GTS Newsletter

2009/10E

Machine	TASKI swingo XP
Subassembly	Brush lowering device

Spring bracket to brush lowering device

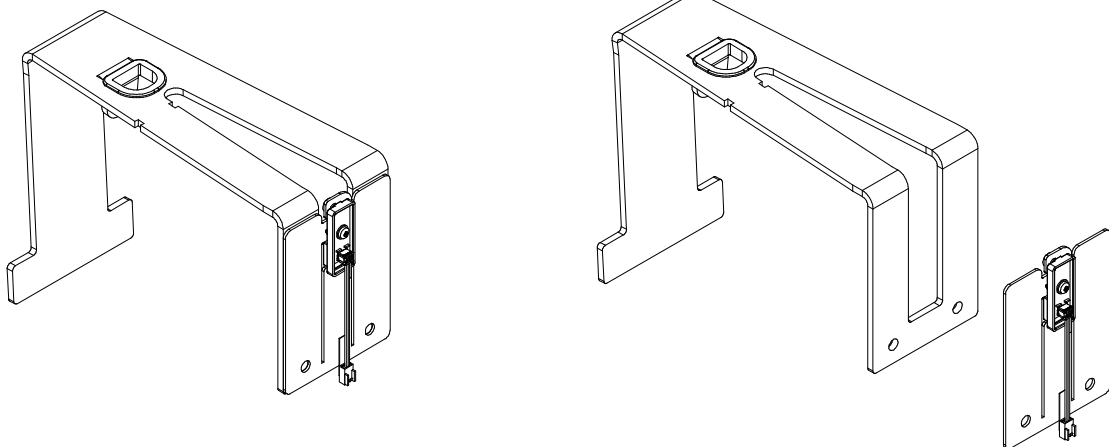
After some verifications of a special cleaning procedure (maximum brush pressure, no chemical detergent used) we have modified the spring bracket.

We mounted the hall sensor on a separate spring steel plate. With this modification we proactively react to a potential deformation of the spring bracket due to deterioration and extreme usage.

With immediate effect we introduce a two-part spring bracket (spring bracket & spring steel plate with hall sensor). Both parts are matched and must always be replaced together.

When installing it has to be paid attention that the "switching reed" which is providing the magnitude to the hall sensor, can swing loose (meaning is, that it does not touch the bracket during the full movement).

The new spring bracket is backward compatible and can be ordered under the existing material number 4127105 (18602-61).
